SERVICE BULLETIN

AT96-003b

NTB96-009b

RE4F04A AUTOMATIC TRANSMISSION (A/T) - WILL NOT SHIFT WHEN PLACED IN REVERSE

Figure 1

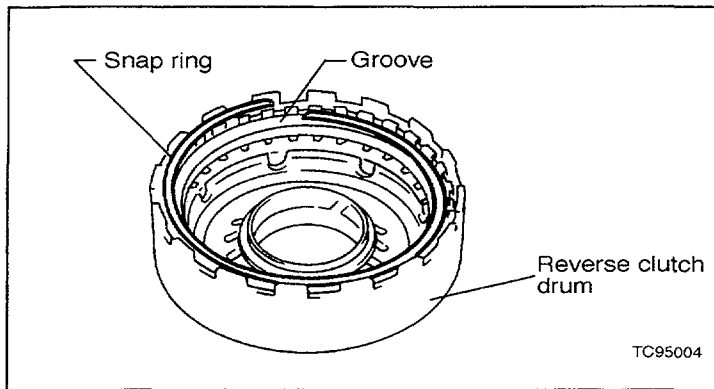
The reverse clutch drum snap ring may pop out of the inner drum retaining groove to cause this incident. A countermeasure reverse clutch drum, snap ring, and 2 dish plates have been developed to resolve this incident.

3. Perform a line pressure test using Kent-Moore J34301-C A/T pressure gauges. If the snap ring has popped out (refer to Figure 1), the line pressure in reverse will be low or zero.

4. If the line pressure is low or zero, remove the reverse clutch drum and inspect the snap ring and retaining groove. If the snap ring has popped out, replace the snap ring using the part number on the following page. If the reverse clutch inner drum retaining groove shows signs of wear, replace the reverse clutch drum using the part numbers listed on the following page.
